#### **Texas Commission on Environmental Quality Waste Permits Division Correspondence Cover Sheet**

Chisholm Trail Disposal Landfill TCEQ Permit No. MSW 2421

Type IV Municipal Solid Waste Landfill Permit Application

Technical NOD 3, Tracking No. 29623137

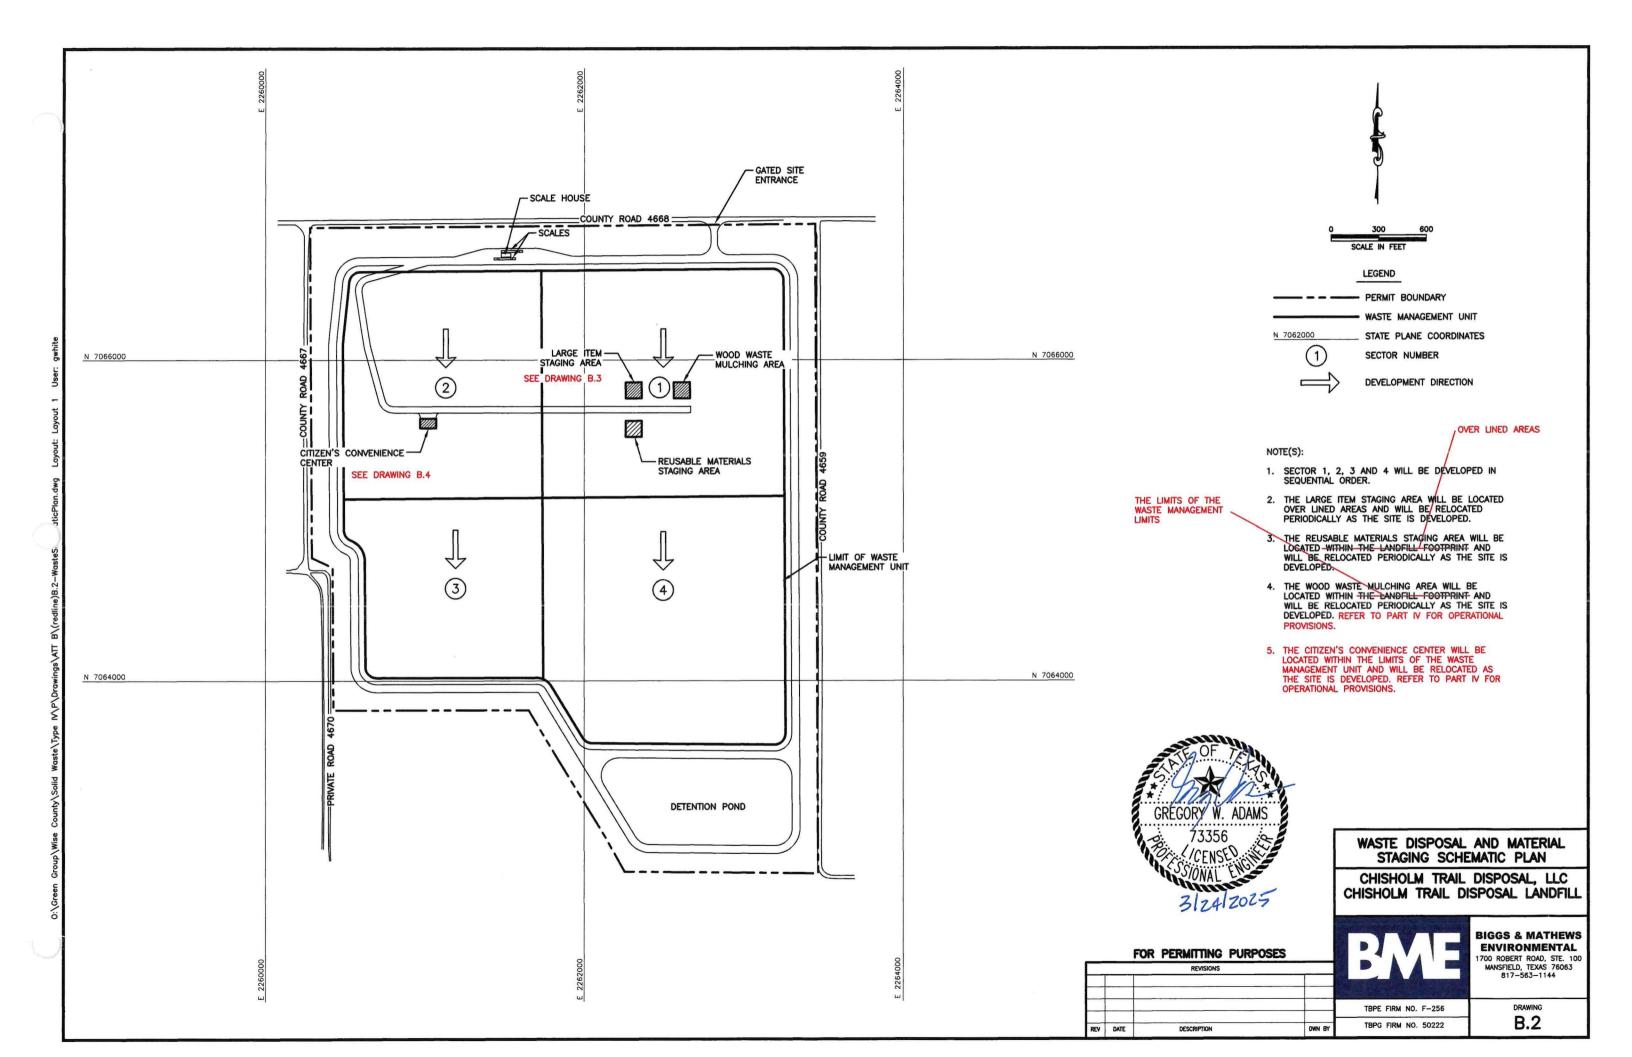
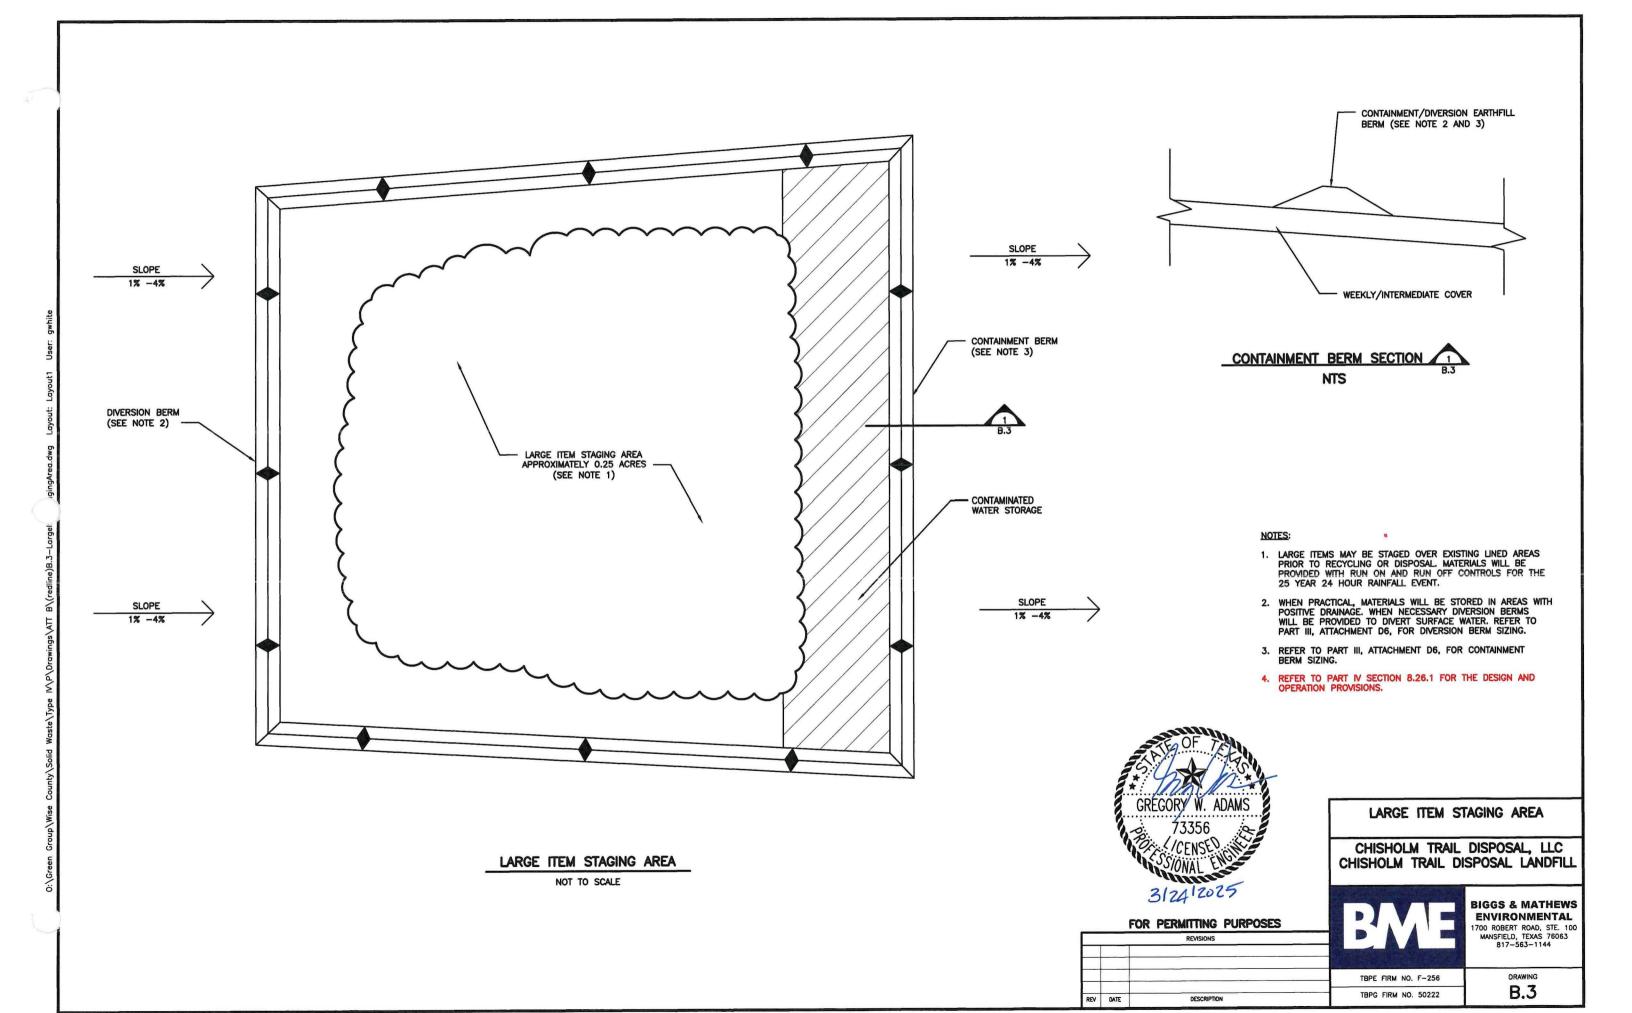
5. For the Large Item Staging Area depicted in Drawing B.1, remove "metals" and replace "recycled" with "disposed of in the landfill working face," to be consistent with the descriptions on Page 2.

- 6. 1. Add a note to Drawing B.2 to provide necessary information on the citizens' convenience center; and to refer to Part IV for its operation provisions.

- 2. Revise Note 3 to Drawing B.2 by inserting "over existing lined areas" between "located" and "within."
  - 3. Revise Note 4 to Drawing B.2 to refer to Part IV for operation provisions for the wood mulching area.

- 4. Drawing B.2 shows the citizens' convenience center at a location within the footprint, conflicting with the last paragraph on Page 3. Revise Drawing B.2 to reflect the correct location of the citizens' convenience center. Also, revise other relevant portions of the application to reflect the correct location of the citizens' convenience center (for example, but not limited to, Drawing D1.2 of Attachment D1.).

#### RESPONSE: Drawing B.1 has been revised as requested.

- 1. Drawing B.2 has been revised as requested.
- 2. Drawing B.2 has been revised as requested.
- 3. Drawing B.2 has been revised as requested.

#### EXISTING CONDITION/POSTDEVELOPMENT BOUNDARY ANALYSIS SUMMARY TABLE

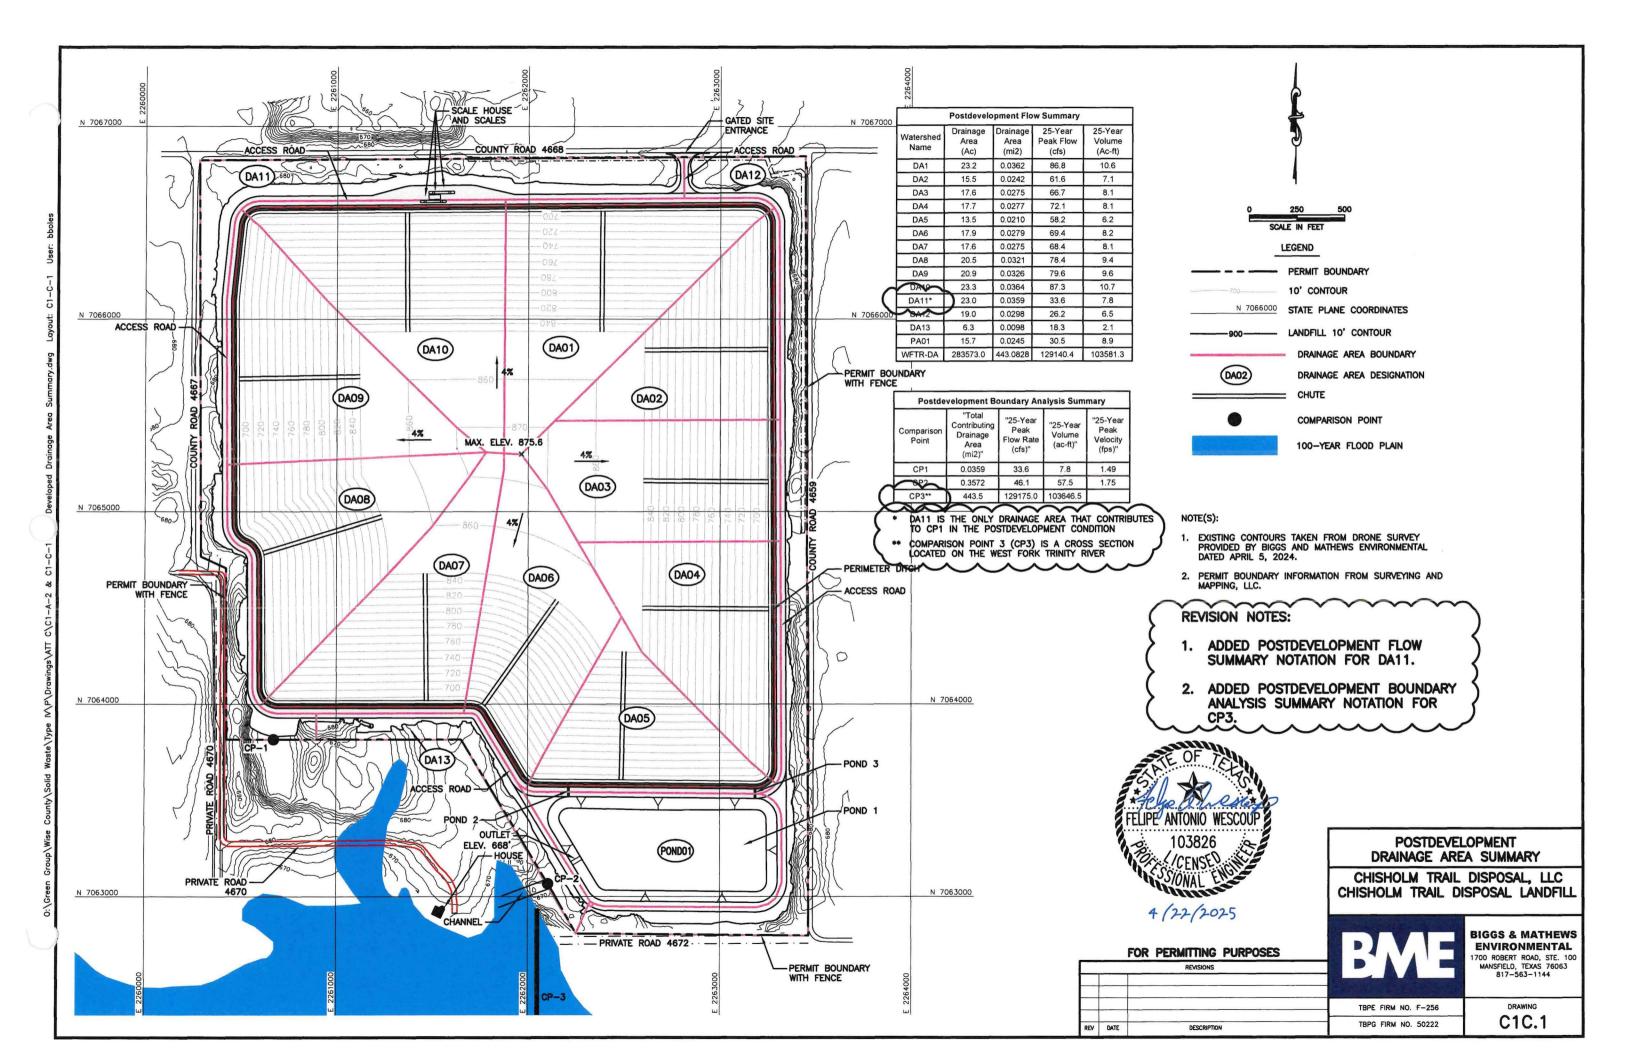
- 2. Revise Section 1.3 in Attachment C1 to briefly discuss the drainage area lost/gained between CP-1 and CP-2.
  - 3. Revise Drawing C1A.2 to show the drainage area exchanges.

- 4. Revise the list on Drawing C1A.2 to identify drainage areas discharging via CP-1 and CP-2, respectively.
  - 5. Revise Section 7 of Attachment C1 to describe if CP-1 discharge is overland flow, concentrated flow, or other (ensure the descriptions are consistent throughout the application). Identify structure/profile (constructed or existing) of CP-1 discharge point and erosion prevention measures.

- 3. See response 7.2.
- 4. A note was added to Drawings C1A.2 and C1C.1 stating that only DA11 contributes to CP1 in the postdevelopment condition.
- 5. Section 7 of Attachment C1 was revised per comment. The permit application was reviewed for consistency and no other revisions were made based on this comment.

1. ADDED TURF REINFORCEMENT MATTING NOTE.

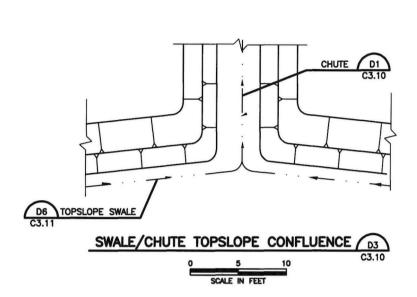
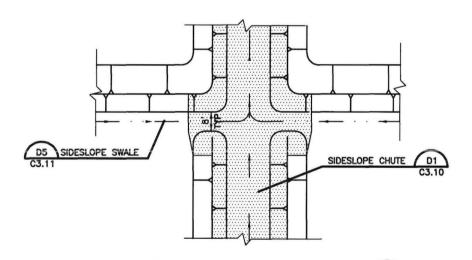
- Revise to provide design and drawings for erosion control/energy dissipation at discharge points/areas of chutes, culverts, pond outlets/spillways.
  - 2. Drawing C3.2 of Attachment C3 shows that pond 1 bottom will be the existing grade. Revise to briefly explain if the pond is designed to be a wet pond and how the unavailable capacity is considered in the design.

- 1. Erosion protection at chute discharges is shown on Drawing C3.9 in Attachment C3. Refer to comment 13.2 regarding erosion protection at pond culverts and spillways.
